Service Letter: No. 329

Subject: Condenser Scoop Bellcrank Replacement & Adjustment Procedure.

Applicability: Bell Helicopter Model,407,427 Equipped with the Air Comm Air Conditioning system.

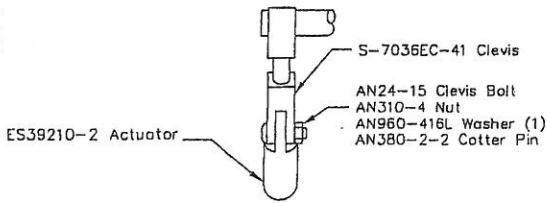
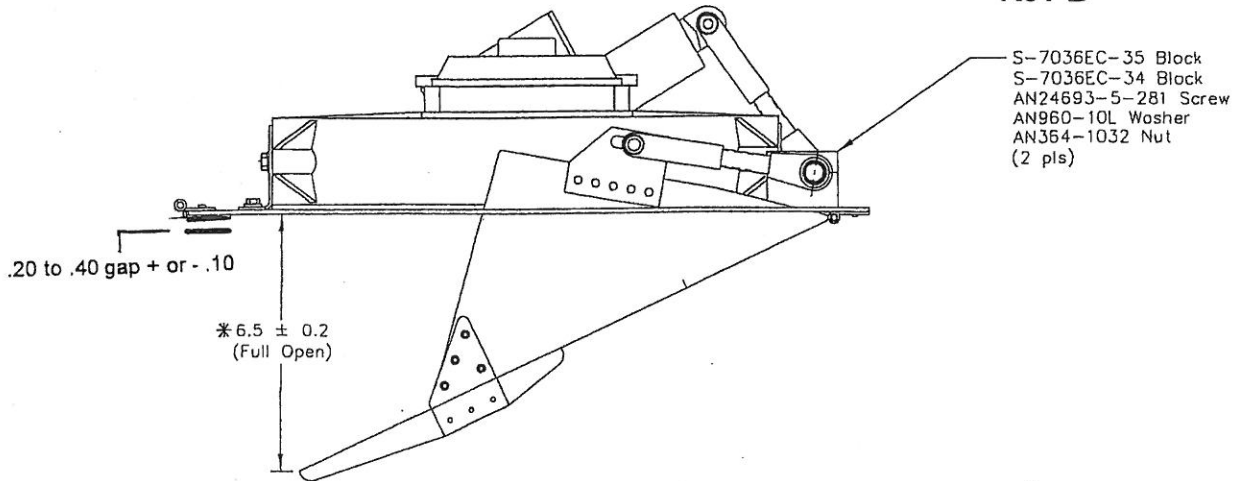
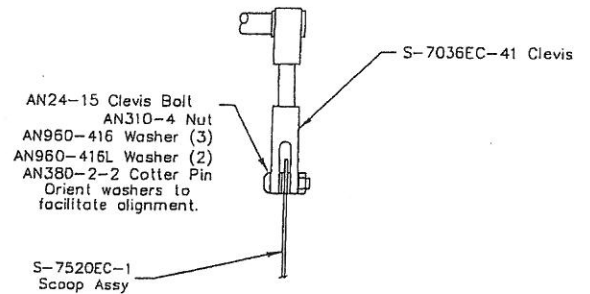
Background: Air Comm Engineering has re-designed the Bellcrank to incorporate a stronger shaft section, and actuator clevis rod assy. S-7036EC-3 /-9. This part is designed to be a "drop in replacement" for the old Bellcrank assy. S- 7037EC-1.

4. Remove hardware from the three clevis / fork ends that attach the bellcrank to the scoop and actuator assemblies.
5. Remove bolts from the bellcrank retaining blocks, remove the old bellcrank S-7036EC-7 and discard. (If applicable).

6. Install new bellcrank assy. S-7037EC-1 in to existing retaining blocks and torque existing nuts to 20 to 30 inch lbs.
7. Install new Clevis ends (S-7036EC-41) on the new bellcrank assy., and temporarily install existing hardware, attaching the actuator arm assy.
NOTE: It maybe necessary to remove a small amount of material from the sides of the actuator attaching point, to allow the free movement of the Clevis end on the actuator arm.

8. Reinstall existing Fork ends on the new bellcrank rod ends and temporarily attach the scoop door using existing hardware. Fork ends will need to be adjusted so there is a gap of approximately .20 to .40 inch between the scoop plate assy. and the scoop door. See drawing on page 3 of 3.
NOTE: This gap is necessary prevent the bottoming out of scoop door before the limit switch has turned the actuator motor off.

9. Once the gaping procedure is completed, Torque the attaching hardware at the clevis and fork ends to 20 to 25 inch lbs., and cotter pin the nut in place.
